Groundwater Application Review Summary Form

Application # G- 19451

GW Reviewer Stacey Garrison Date Review Completed: 12/17/2024

TO: Water Rights Section Date 12/17/2024
 FROM: Groundwater Section Stacey Garrison
 Reviewer's Name
 SUBJECT: Application G- 19451 Supersedes review of _____
 Date of Review(s)

Theis Interference Analysis

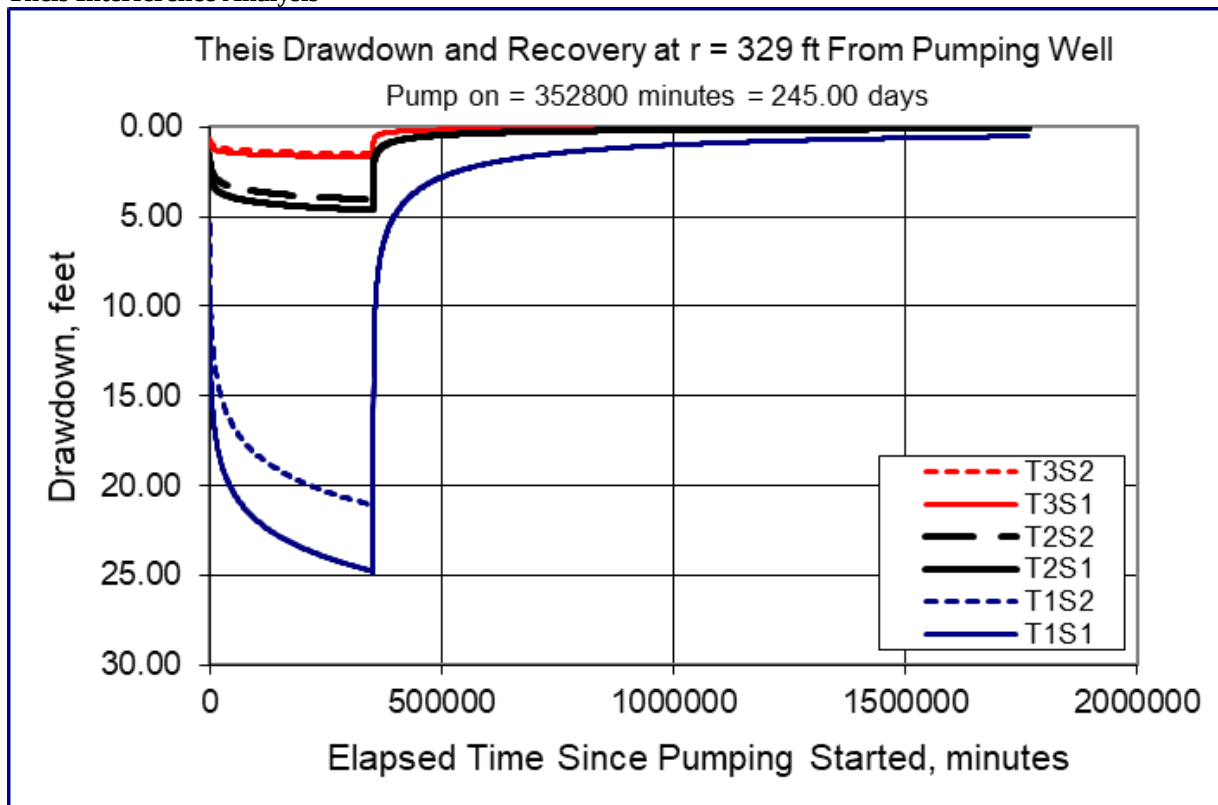
The closest proposed-POA-to-groundwater-user distance is 329 ft between POA 1 (PROP 575) and MARI 7746, authorized under Claim GR 3925 with priority date 11/30/1948. It is likely the proposed use would cause some degree of well-to-well interference with MARI 7746. To assess the degree of drawdown, a Theis drawdown analysis was conducted for the proposed use (see attached Theis Drawdown Analysis). Results indicate that the proposed use is not likely to cause well-to-well interference with MARI 7746 that exceeds the threshold under the standard condition for CRBG aquifers in the Willamette Basin.

Radial distance from pumping well (r)=329 ft [estimated radial distance to nearest user, MARI 7746]

Pumping Rate (Q)= 0.3375 cfs (~151.5 gpm)*

Aquifer Transmissivity (T_1)= 7,600 gpd/ft (1,016 ft²/day), (T_2)= 47,498 gpd/ft (6,350 ft²/day), (T_3)= 142,494 gpd/ft (19,050 ft²/day)

Storativity (s_1) = 0.0001, (s_2) = 0.0005 [Conlon et al 2005, Table 2 values for Central CRB]

Total pumping time=245 days [irrigation season, March 1-October 31]

*The full pumping rate could not be utilized continuously for the entire 245-day period of use without exceeding the 164 ac-ft maximum allowed duty. For the maximum allowed duty of 164 ac-ft, continuous pumping would occur for 245 days at a rate of 0.337484 cfs (~151.473 gpm).

Based on this analysis of the available data and under the assumptions previously identified, groundwater for the proposed use is likely available in the amounts requested within the capacity of the resource. If a water right is permitted for this application, the conditions specified in B1.d. and B2.c. are strongly recommended to protect senior users and the groundwater resource.
